**AMENDMENT UNDER 37 C.F.R. § 1.111**  
U.S. Application No.: 10/091,445

**AMENDMENTS TO THE DRAWINGS**

For: CERAMIC HEATER

**REQUEST FOR APPROVAL OF PROPOSED DRAWING CORRECTIONS**

**Fig. 7**      **PRIOR ART**

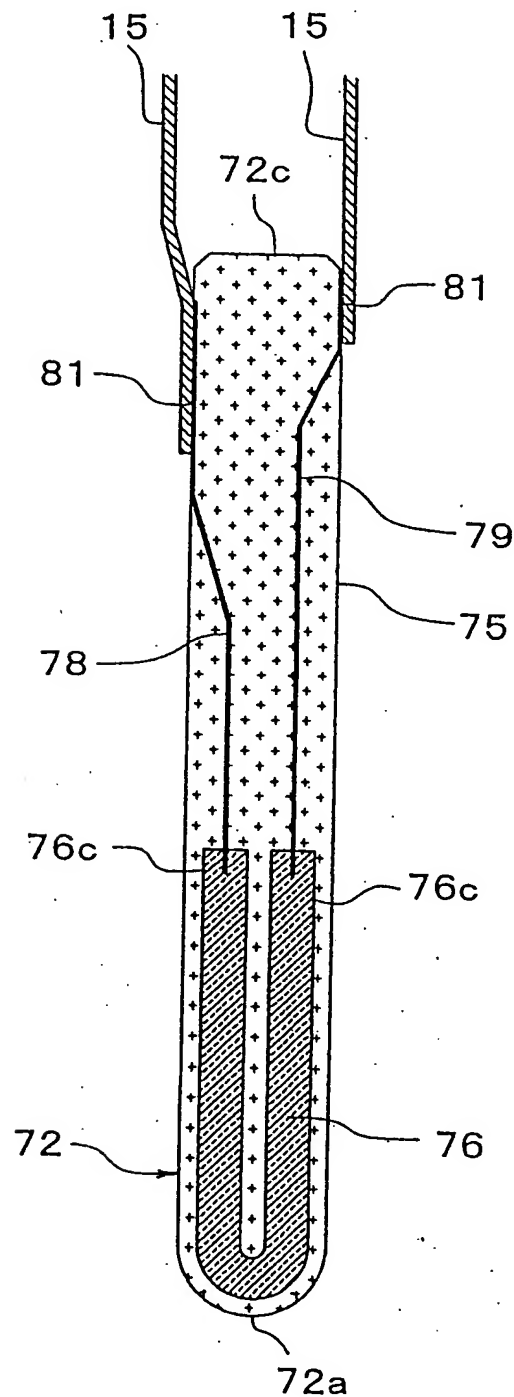
Fig. 7 is amended to be labeled as "PRIOR ART".
